Agenda Item # 10

SUB-003743-2026

Marshall Addition to Myrtlewood Lane Subdivision

- Subdivision approval to create two (2) legal lots of record from one (1) metes-and-bounds parcel.

DETAIL SITE PLAN

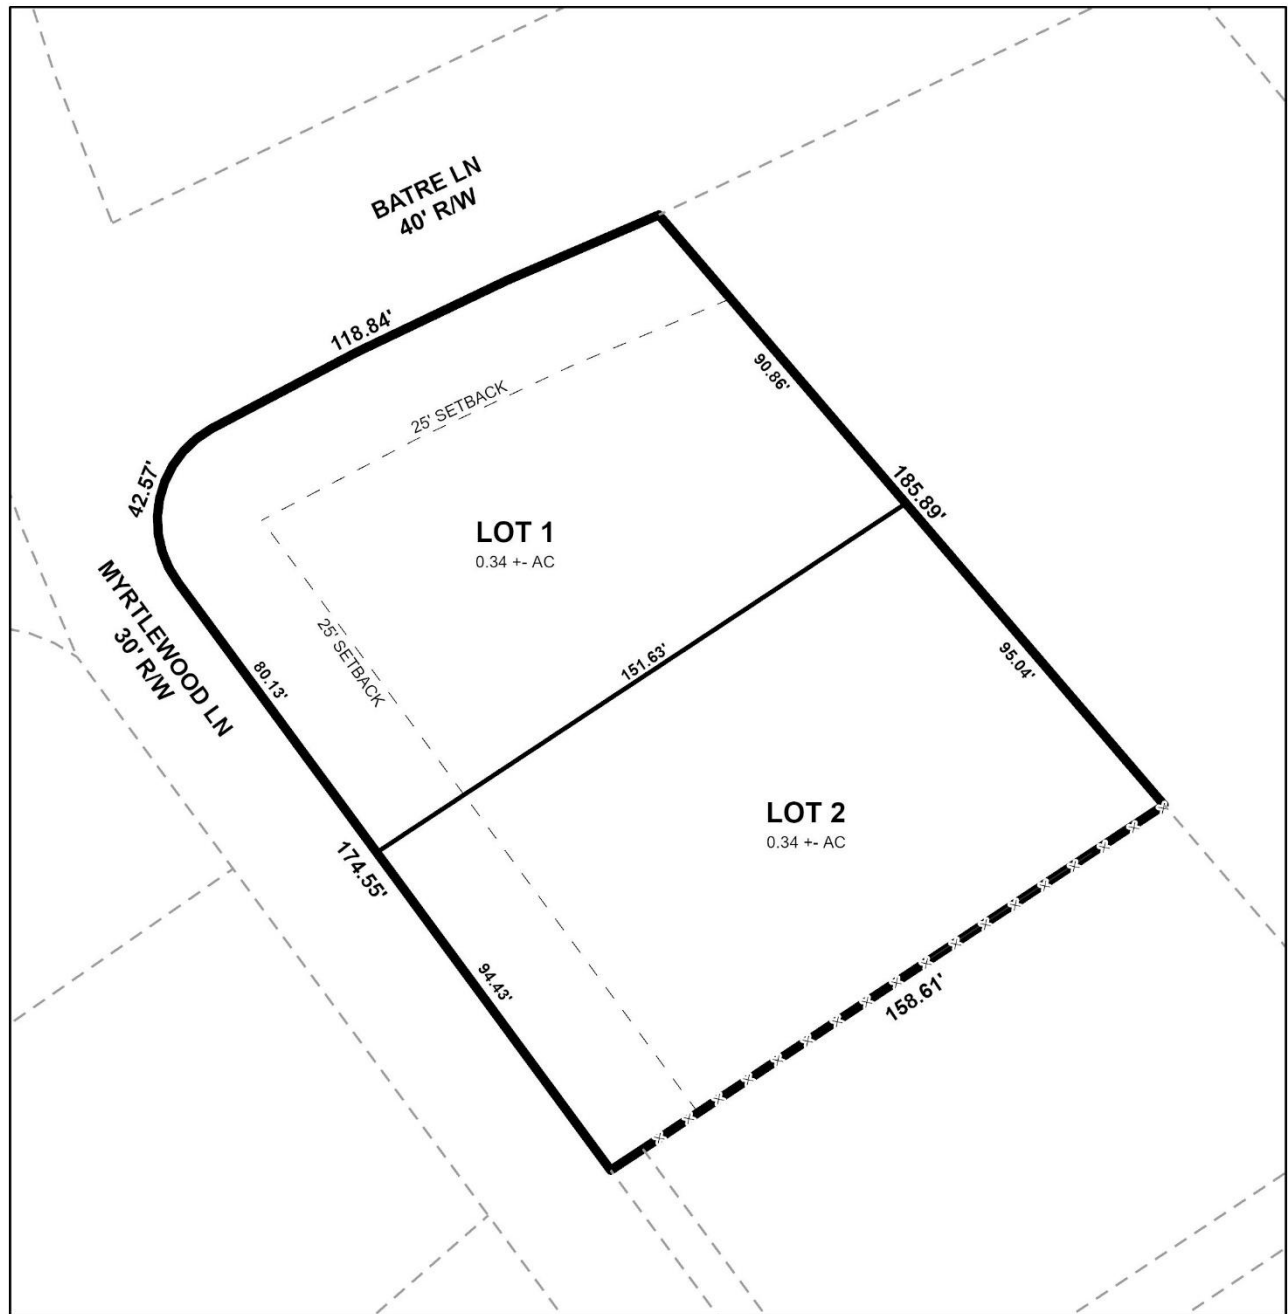
The lots front Myrtlewood Lane and Batre Lane. Both are minor streets with curb and gutter improvements, each requiring a 50-foot-wide right-of-way. The preliminary plat illustrates a 40-foot right-of-way width along Batre Lane and a 30-foot right-of-way width along Myrtlewood Lane. If approved, dedication to provide 25 feet from the centerline of Myrtlewood Lane and 25 feet from the centerline of Batre Lane should be required and illustrated on the Final Plat, unless a waiver of Section 6.B.9. of the Subdivision Regulations is recommended by the City Engineer and Traffic Engineer.

A 25-foot corner radius is depicted where Myrtlewood Lane and Batre Lane intersect, in compliance with Section 6.C.6. of the Subdivision Regulations. This information should be retained on the Final Plat, if approved.

The lots are properly labeled with their sizes in both square feet and acres on the preliminary plat, as required by Section 5.A.2(e).4. of the Subdivision Regulations. If approved, this information should be retained on the Final Plat, adjusted for any required dedication; alternatively, a table providing the same data is acceptable.

A 25-foot minimum front yard setback is illustrated along Myrtlewood Lane and Batre Lane, as required by Section 6.C.8. of the Subdivision Regulations and Article 2, Section 64-2-5.E. of the UDC. If approved, this information should be retained on the Final Plat, adjusted for any required dedication.

1. Dedication to provide 25 feet from the centerline of Myrtlewood Lane, unless a waiver of Section 6.B.9 is recommended by the City Engineer and Traffic Engineer;

2. Dedication to provide 25 feet from the centerline of Batre Lane, unless a waiver of Section 6.B.9 is recommended by the City Engineer and Traffic Engineer;

3. Retention of the 25-foot corner radius at the intersection of Myrtlewood Lane and Batre Lane, in compliance with Section 6.C.6. of the Subdivision Regulations;

4. Retention of the lot sizes in both square feet and acres, or provision of a table on the Final Plat with the same information, adjusted for any required dedication;

5. Retention of the 25-foot minimum front yard setback line along Myrtlewood Lane and Batre Lane, adjusted for any required dedication;
6. Compliance with all Engineering comments noted in this staff report;
